**TOWN OF NEWBURGH
PLANNING BOARD
TECHNICAL REVIEW COMMENTS**

PROJECT: CHADWICK WOODS SUBDIVISION
PROJECT NO.: 19-02
PROJECT LOCATION: SECTION 14, BLOCK 1, LOT 51
REVIEW DATE: 14 MAY 2021
MEETING DATE: 20 MAY 2021
PROJECT REPRESENTATIVE: TALCOTT ENGINEERING/CHARLES BROWN

Re: Resubmission Letter
Chadwick Woods Subdivision
Town Project No. 2019-02
NYS Route 300
SBL: 14-1-51
Job No. 17100-MMR

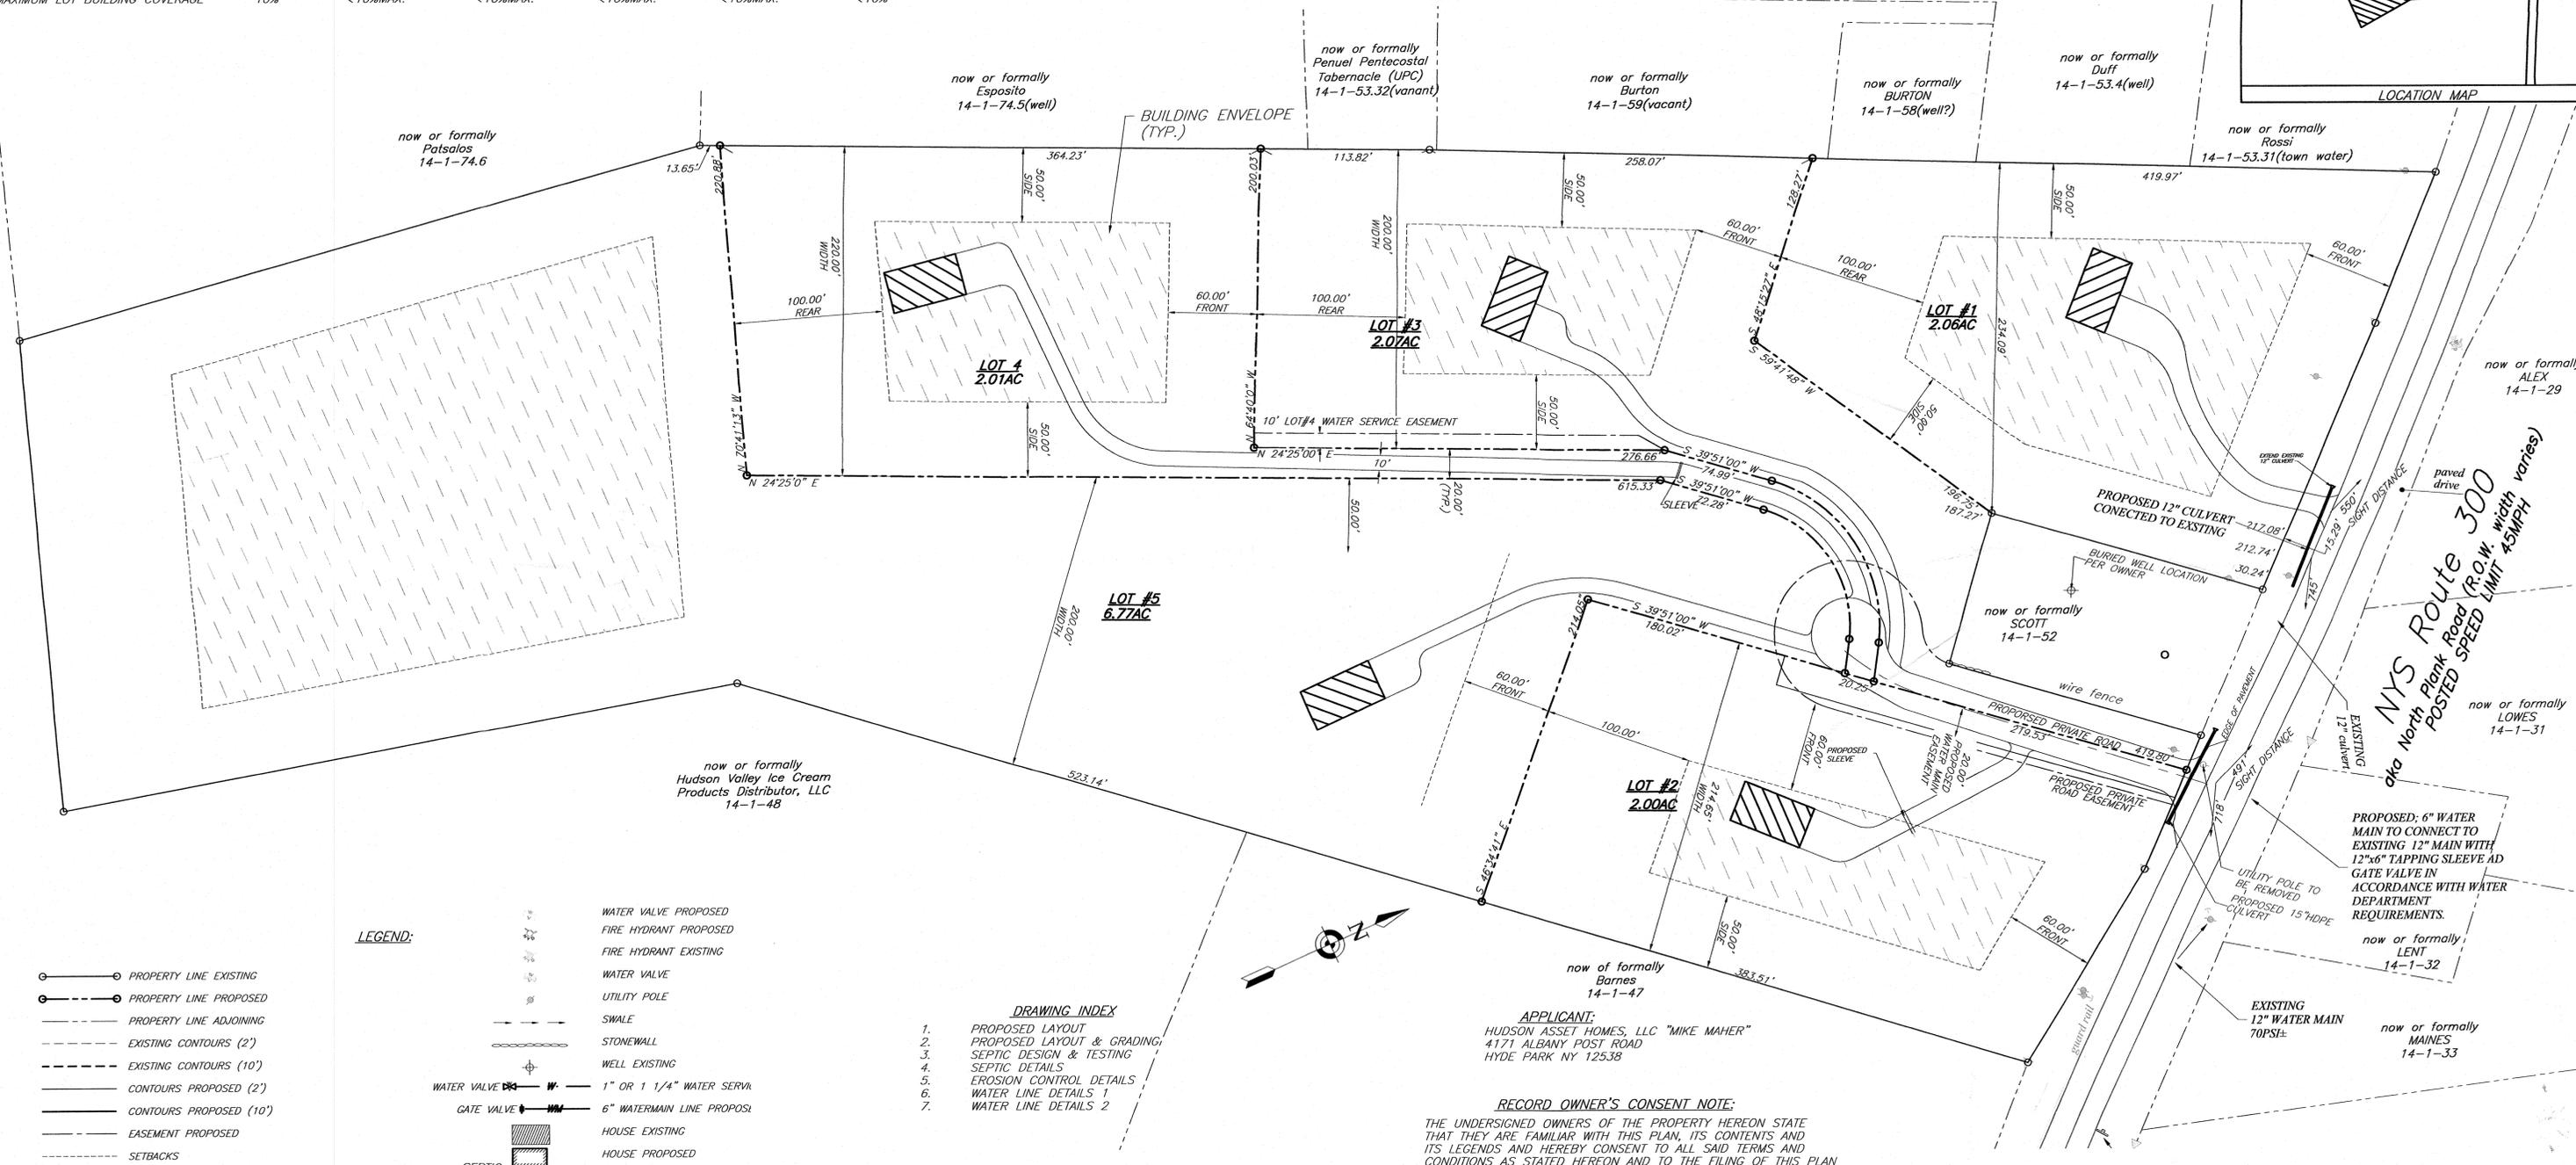
8. Sheet 1 of 7 does not identify a building envelope on Lot #5.

- 12) Booster pumps are no longer proposed.
- 13) An easement on Lot 3 for Lot 4 water service is now shown.
- 14) Will be addressed by applicants attorney.
- 15) Changed as requested.
- 16) Building envelopes are shown on sheet 1.
- 17) See 9) above.
- 18) The SWPPP is currently being generated.

THRUST BLOCK DETAIL
(NOT TO SCALE)

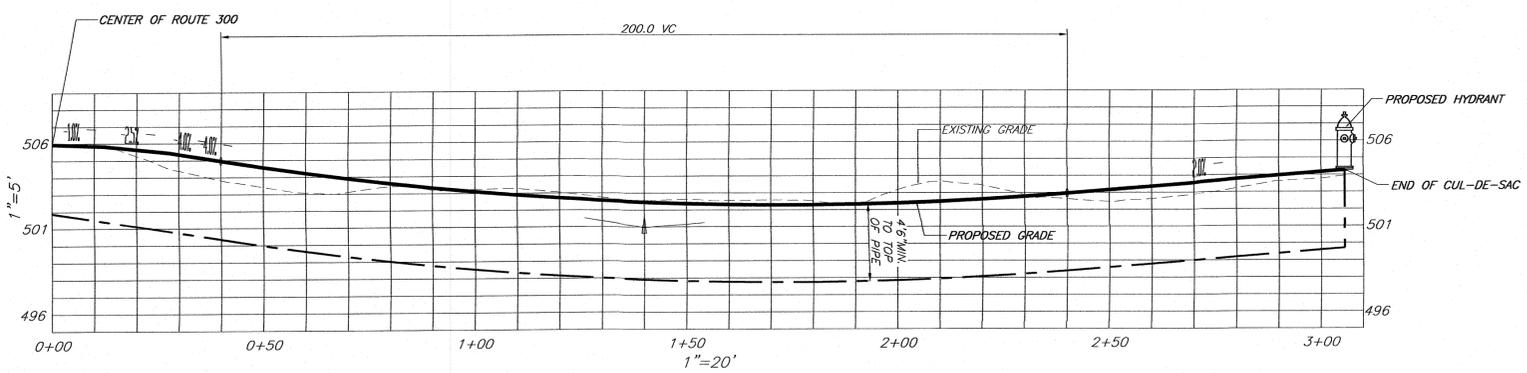
4. Reference to booster pump stations Note #11 Sheet 6 of 7 should be removed from the plans.
5. The restrained joint pipe chart must be added the plans. Current water details identify thrust blocks. Thrust blocks are not permitted for the Town of Newburgh system.

- 7) New 6" water main will be ductile iron.
- 8) Pipe joist restraints have been added to the plans.
- 9) The hydrant is new. Gate valves are all shown. The Water Department has not yet provided details.
